6 Albert Terrace Mews
London, NW1 7TA

Basement Impact Assessment
Audit

London Borough of Camden

Project Number: 12985-14
Revision: F1

drg. no.
1808/21/M02

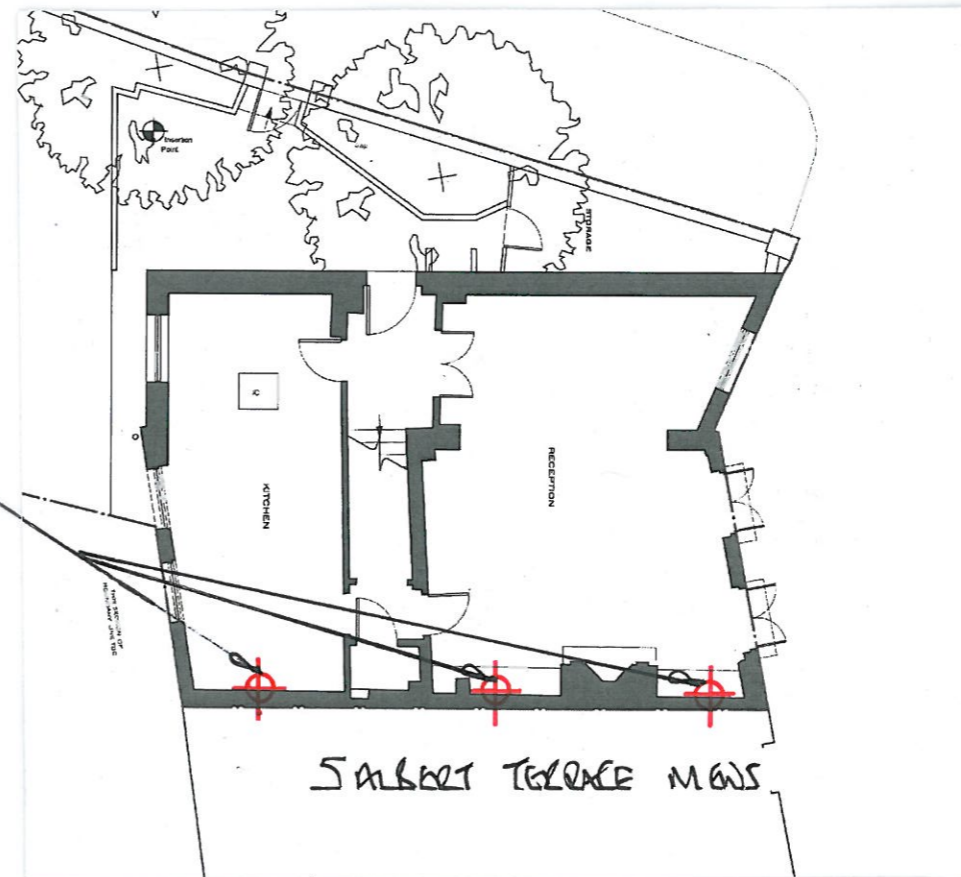
- 4.28. Section 7.3.1 of the RSK BIA recommends movement monitoring as part of proposals to control ground movements, however this is not mentioned in the Alan Baxter report which is the main document supporting this application. Outline proposals were not included and this was requested with trigger values based on the GMA to ensure damage impacts remain within the agreed limits. An outline monitoring proposal by Alan Baxter is included in the revised submission (see Appendix 3).

- 5.13. An outline structural monitoring strategy is now presented. A detailed proposal should be agreed with the relevant parties prior to construction.

WE PROPOSE TO MONITOR THE FRONT & REAR ELEVATIONS AND THE PARTY WALLS FORTNIGHTLY DURING THE UNDERPINNING WORKS AND 6 WEEKS AFTER COMPLETION WE PROPOSE THE RED AND AMBER TRIGGER LEVELS TO BE:

HORIZONTAL MOVEMENT:

AMBER: 5mm
RED: 7mm

VERTICAL MOVEMENT

AMBER: 6mm
RED: 10mm
